**FLORIDA POLYTECHNIC UNIVERSITY
DEPARTMENT OF PROCUREMENT
LAKELAND, FL
ITB 26-004
INTERNET SERVICES**

**Addendum: One (1)
Date: 08/06/2025**

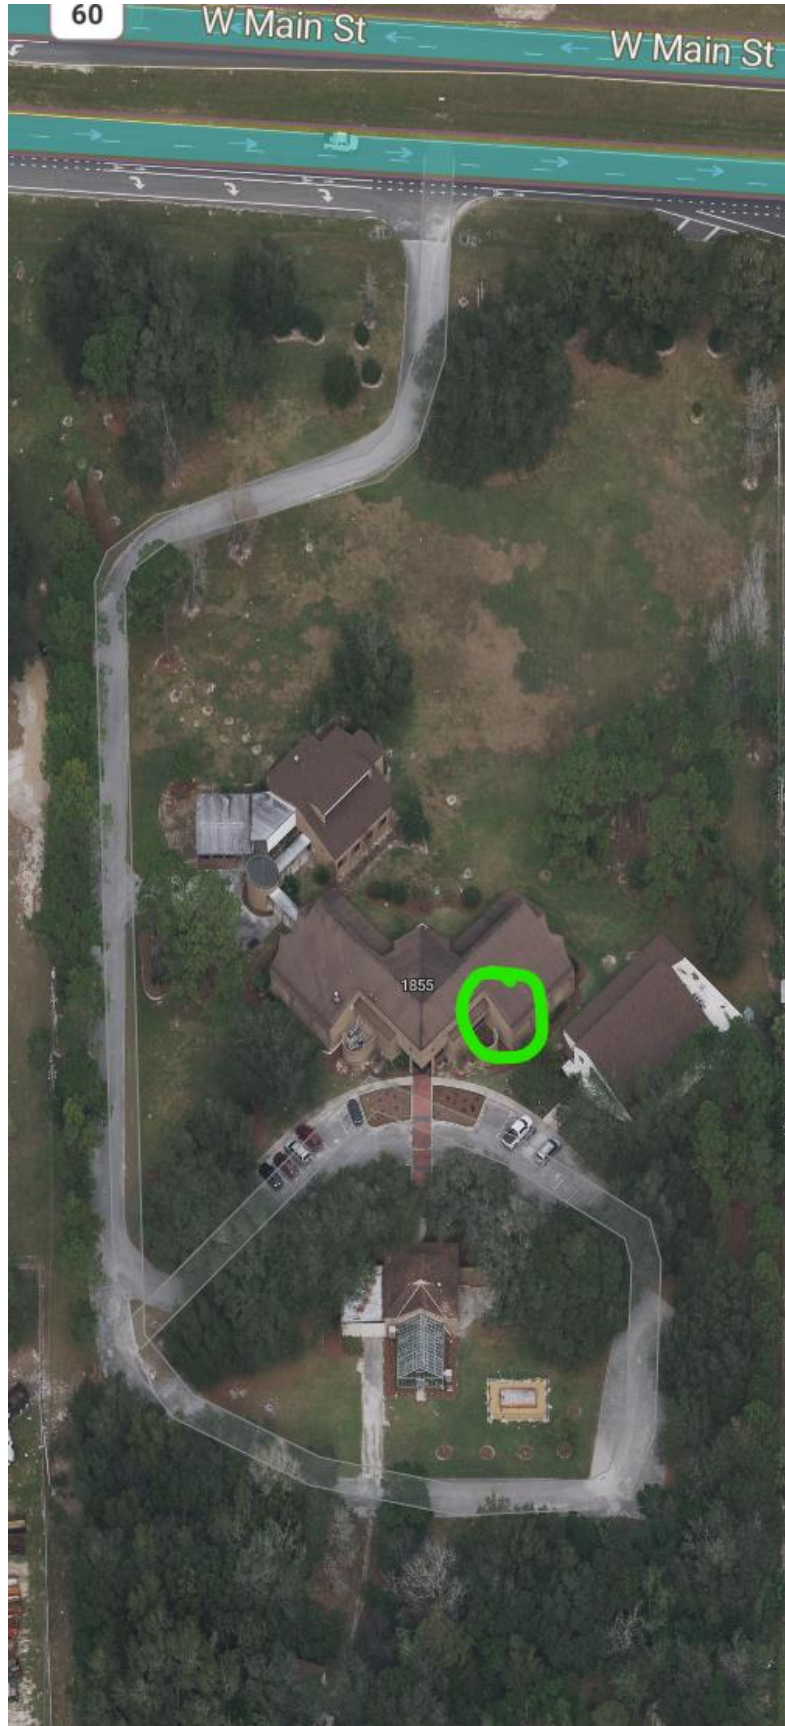
8. **FIBR & LTB** - is there a particular building that we will be connecting to? A site plan showing DMARC would be helpful.

FIPR service shall be terminated in the FIPR Administration Building in roughly the location outlined in the green circle below.
